Submitted to
American Electric Power
1 Riverside Plaza
Columbus, OH 43215-2372

Submitted by
AECOM
277 West Nationwide Blvd
Columbus, OH 43215

Flint Creek Power Plant: CCR Rule Structural Stability Evaluation

February 2016

AECOM	CCR Rule Structural Stability Certification AEP Flint Creek Power Plant, Gentry, AR	**p'-q Plot** **Drained Shear Strengths**	Figure 1
	Project No. 60437225 / Date: December 2015

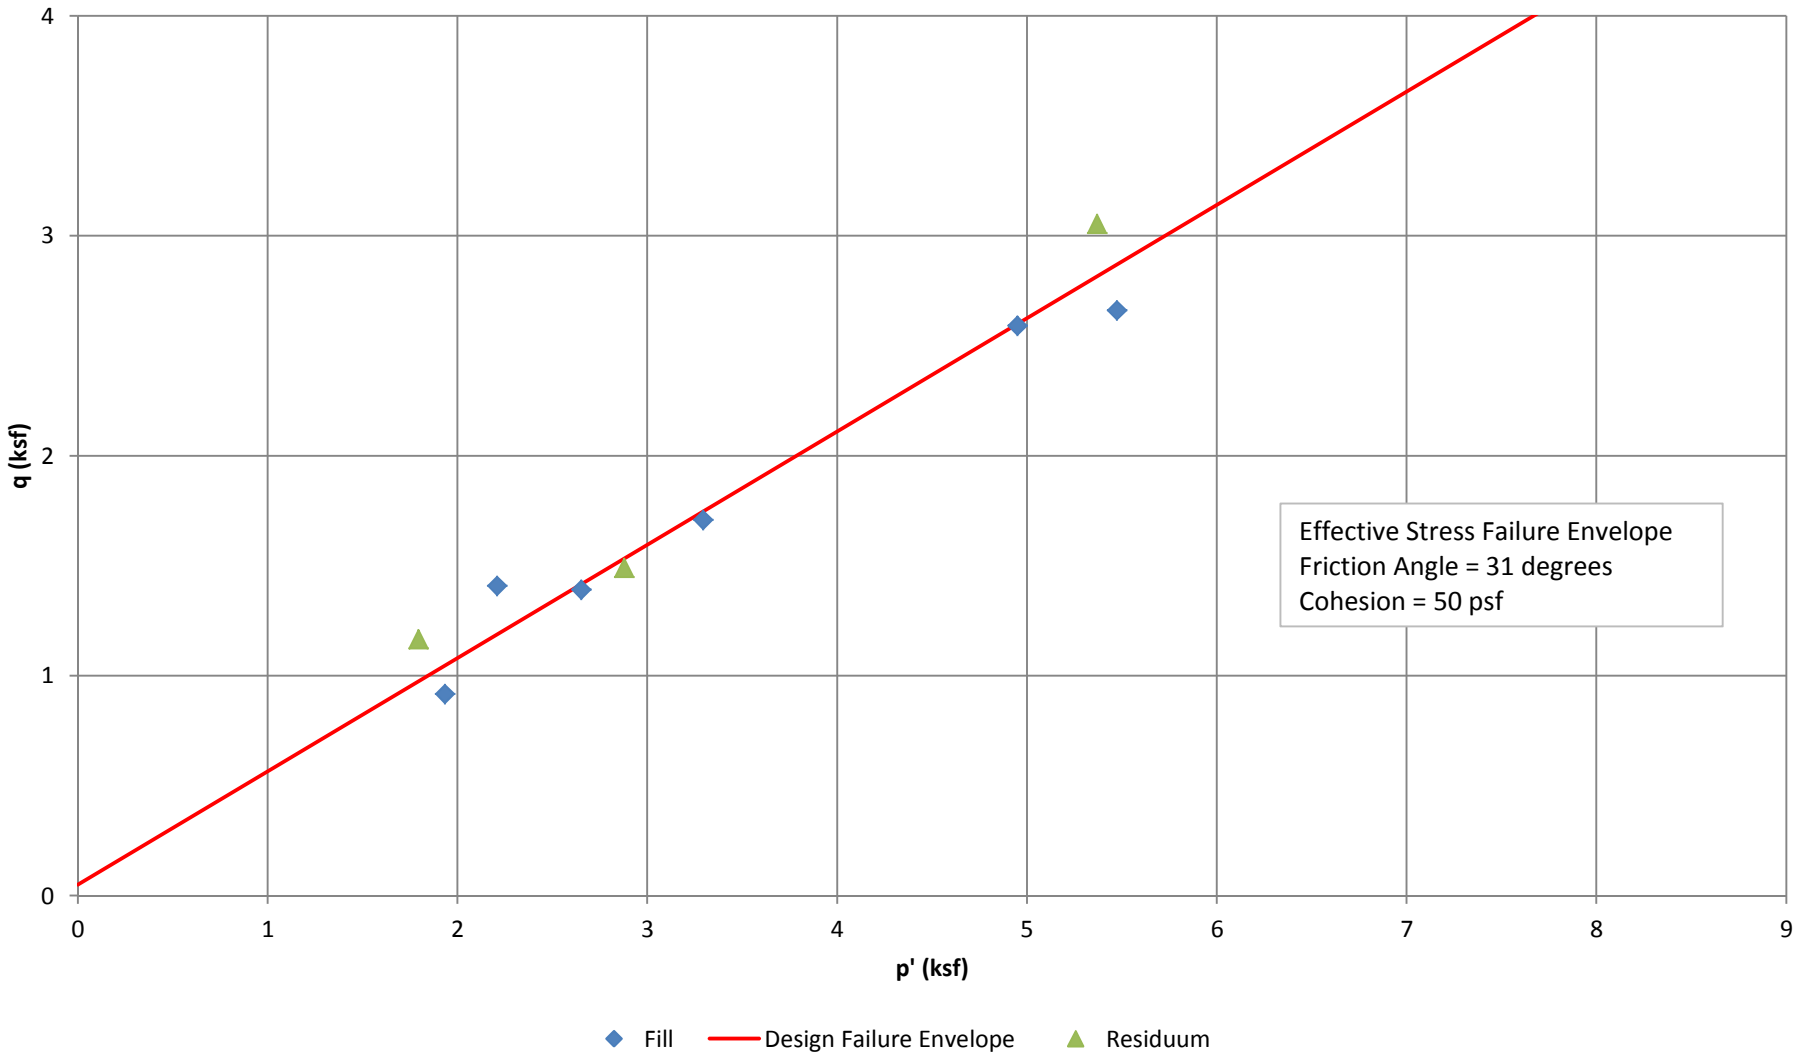
The results of the Isotropically Consolidated Undrained (CIU) triaxial tests were plotted by AECOM on p'-q and p-q plots (see Figures 1 and 2). Failure was defined using the maximum stress difference criteria (σ_1 - σ_3 or the maximum deviator stress), as the ETTL report does not contain sufficient data to also define failure using the maximum ratio of principal effective stresses during the triaxial test (σ_1 / σ_3 or maximum obliquity). Failure at maximum deviator stress was plotted as a single point for the two different material types (fill and residuum/native soil) present at both ponds. In reviewing Figures 1 and 2, AECOM found that the embankment fill and residuum soils all plotted consistently on a single failure envelope for both ponds, indicating that the two materials have similar shear strengths. This is not unexpected as the embankment fills are most likely well-compacted residuum. Appendix A presents the background and findings for the development of the design shear strengths. Table 2 provides a summary of the soil parameters selected by AECOM for our independent analyses.

amount of data. AECOM has not typically reduced the shear strength data in the past based on sparse data and instead has used the peak shear strengths (as shown in Table 2) for our independent slope stability analyses. AECOM also included a 2 foot thick layer of riprap along the downstream face of the slope extending from the top of the dam to the toe. The riprap face was observed during the site visit as well as from aerial imagery in Google Earth. The parameters assumed for the riprap are provided in Table 2 and were developed using engineering judgment and experience. AECOM also reviewed ETTL's shear strength values for Native Rock, and found them to be somewhat conservative for weathered limestone. However, the strength of the Native Rock is unlikely to substantially affect the slope stability analyses, as most slip surfaces will be confined to the lower-strength fill and residuum.

Figure 4

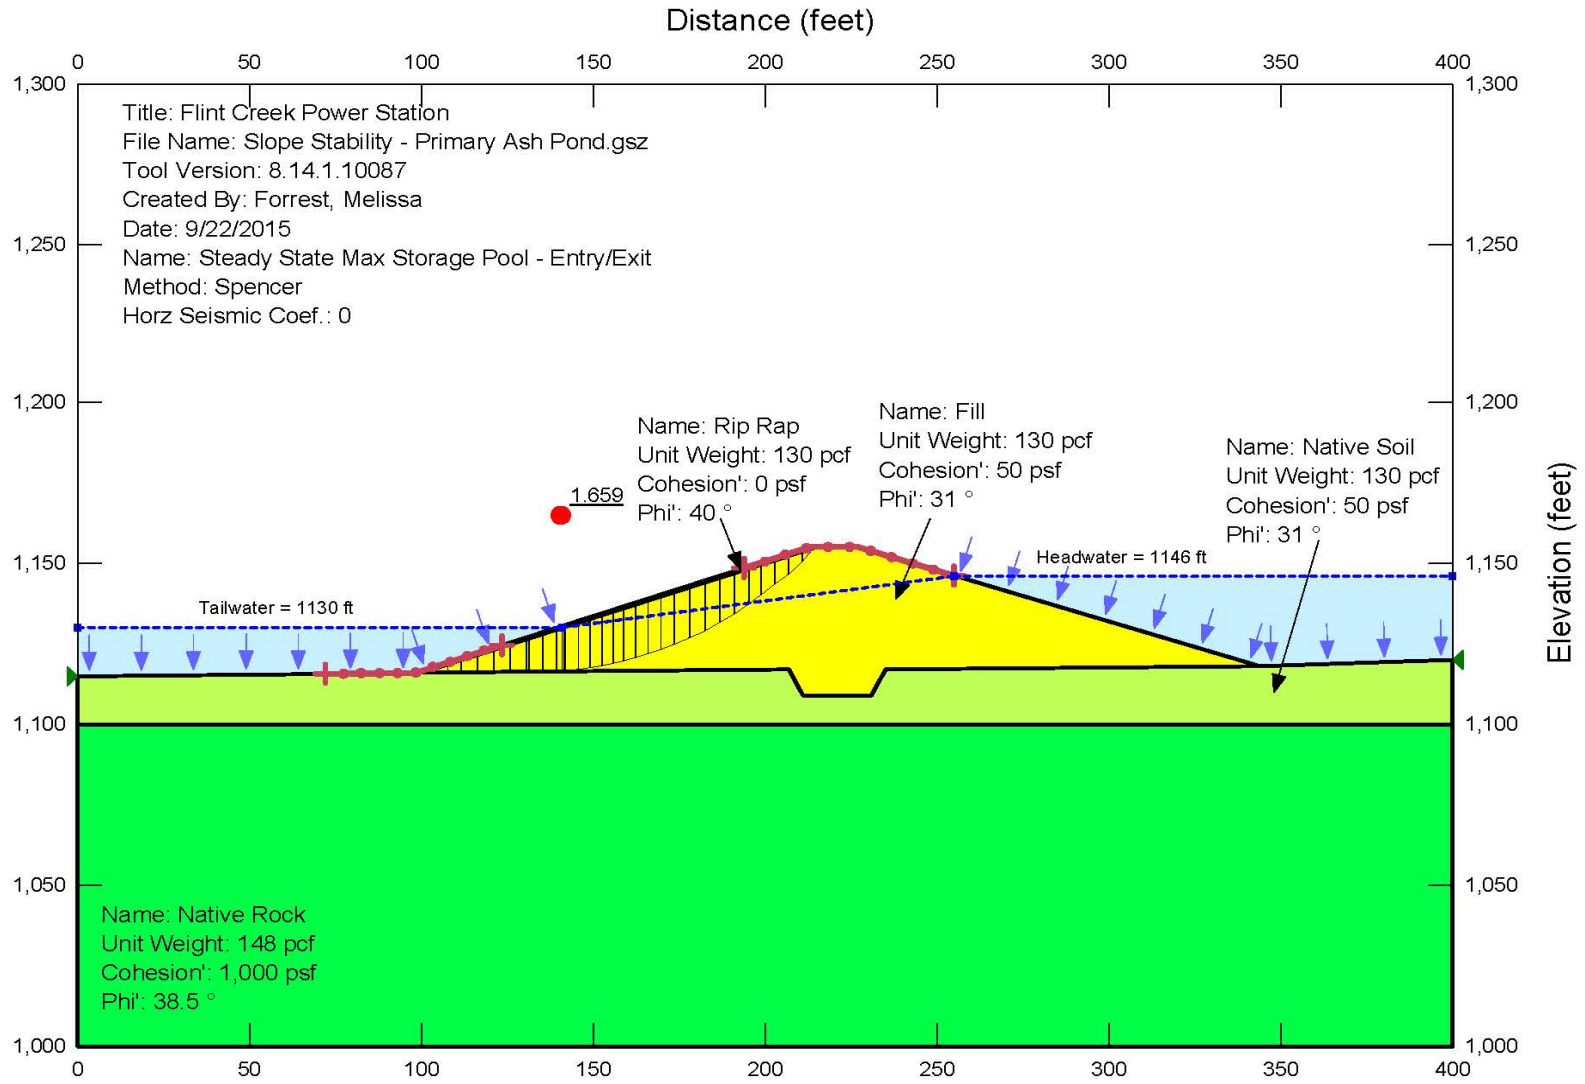
The graphical slope stability analysis results are provided in Figures 4 through 6 for the Primary Ash Pond and Figures 7 through 9 for the Secondary Ash Pond. A summary of the slope stability FoS results are shown in Table 4. Each analyzed case meets the rule's minimum FoS requirements.
